SAFETY RECALL BULLETIN

NHTSA RECALL 23V019

AUTOCAR, LLC SAFETY RECALL ACX-2302

Autocar, LLC has determined that certain ACX models manufactured with an external sun visor obstructs the roof mounted clearance lamps.

Figure 6

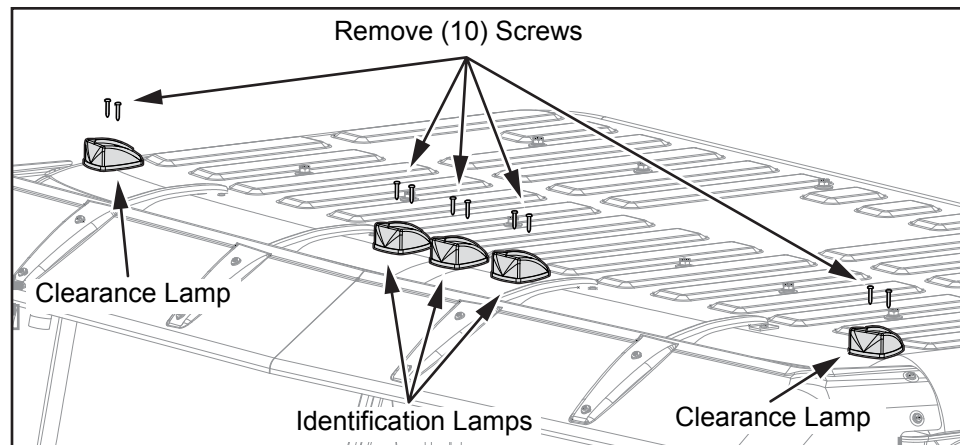
6. Locate the clearance and identification lamps. Remove and discard (10) mounting screws. Remove the clearance and identification lamps and set aside for reinstallation. Remove and discard any remaining seal and sealant from the cab roof and lamps (See Figure 6).

Figure 7

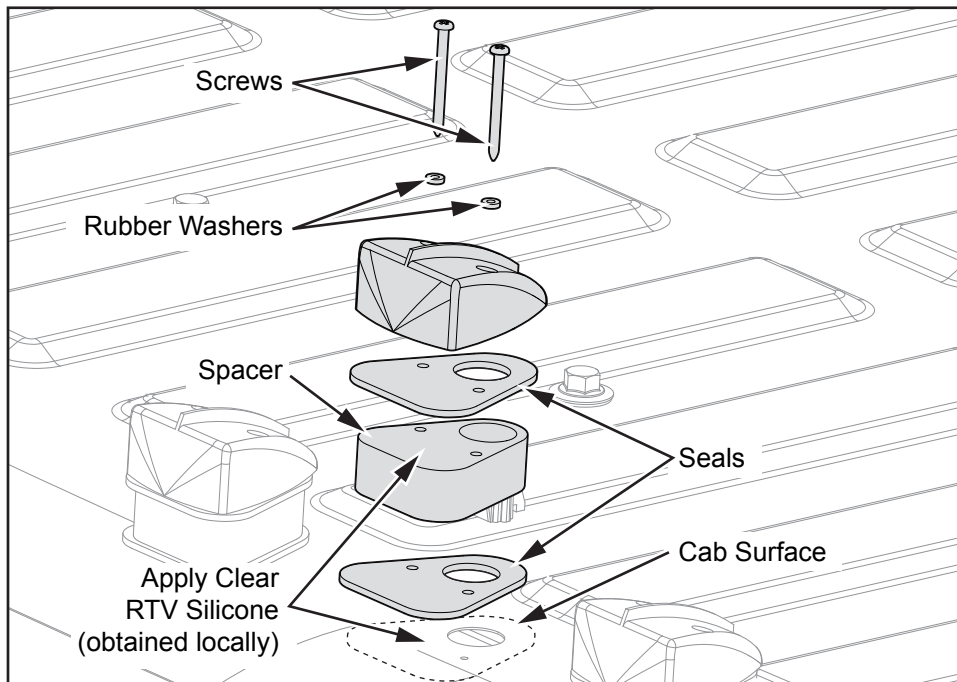
7. Apply clear RTV silicone (obtained locally) to the cab and spacer surface. Install (1) A8510067-001 spacer, (2) A8510068-001 seals, (2) GZ05003-001 rubber washers and the marker lamps set aside in step 6, using (2) GZ030010-002 screws. Repeat this process for the remaining (4) lamps (See Figure 7).
